Subject: REAR DIFFERENTIAL VENT CAP FLUID LEAK IN COLD AMBIENT TEMPERATURES	Bulletin No: 03-003/13
	Last Issued: 10/31/2013

2011 Tribute equipped with AWD

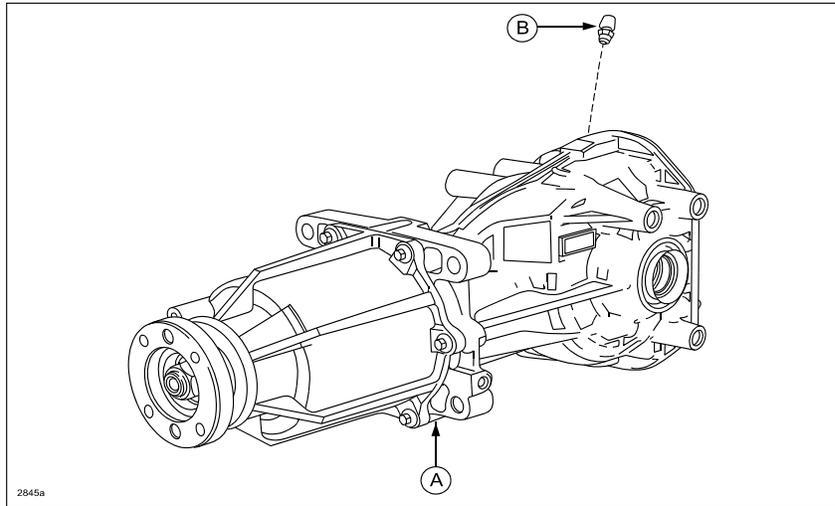
1. Inspect the rear drive unit (A) for oil leaking from the vent cap (B) located on the rear cover.

3. Remove and discard the vent from the rear drive unit cover.
4. Install new vent.
5. Clean off any remaining residue.
6. Verify repair.
